PRODUCT CHANGE NOTIFICATION

Bourns® Model PAD00x-T764 Series Push-Pull Isolation Transformer *Change to Case and Potted Design*

IC23024

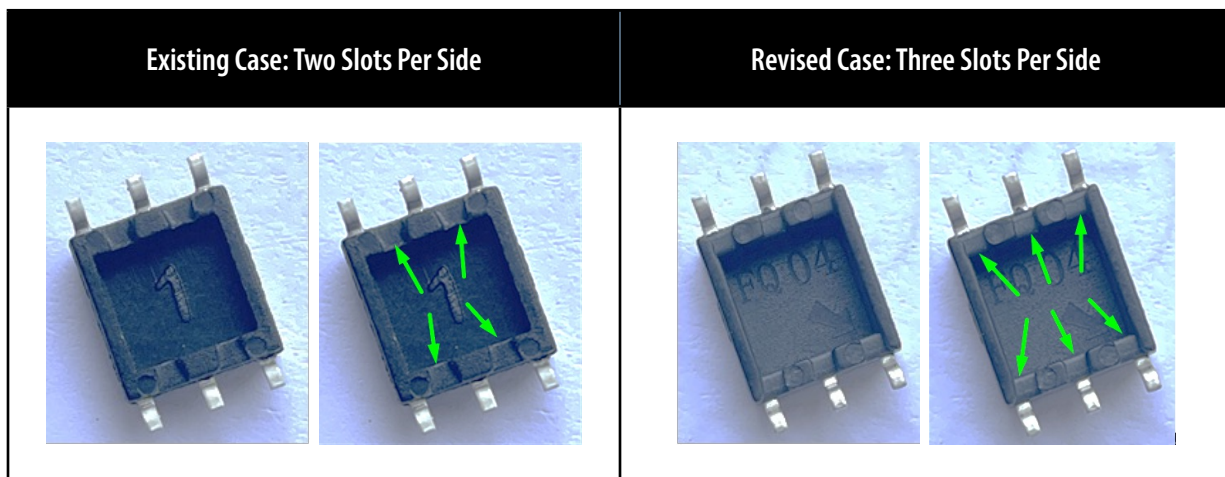
The transformer case will be changed from two lead slots to three lead slots. This will reduce the length of the tin wire and the risk of short circuit between the windings. The change to the case is shown below:

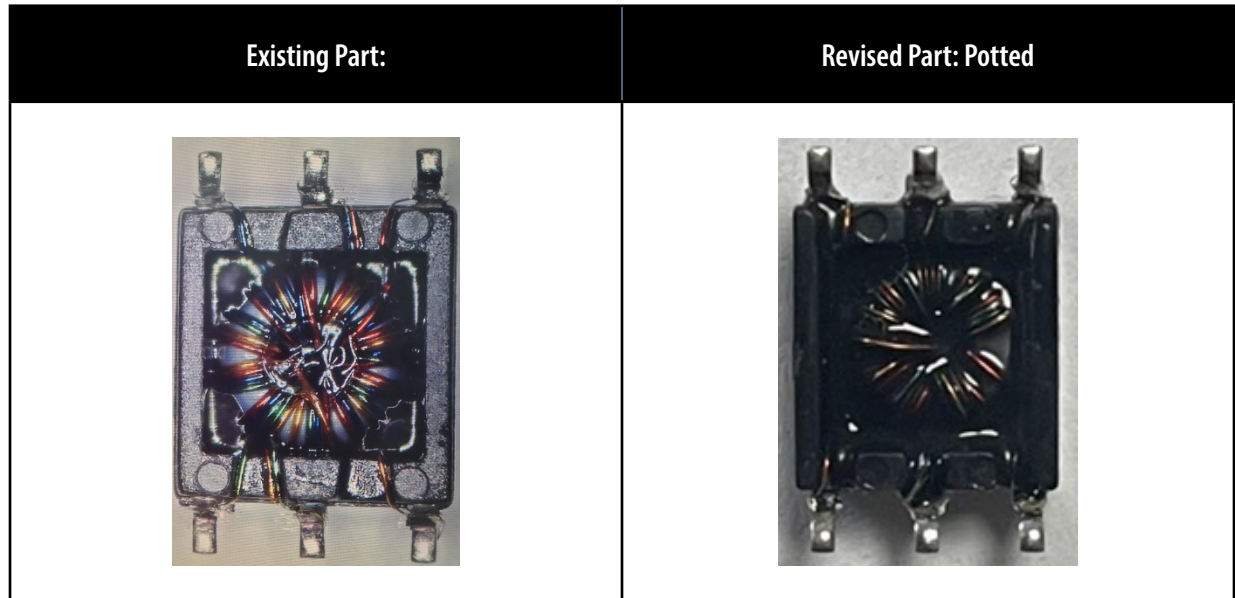
The transformer winding will change from a partial potting to be fully covered with the potting material. This change should improve reliability, durability, and winding insulation. The change to the potting is shown below:
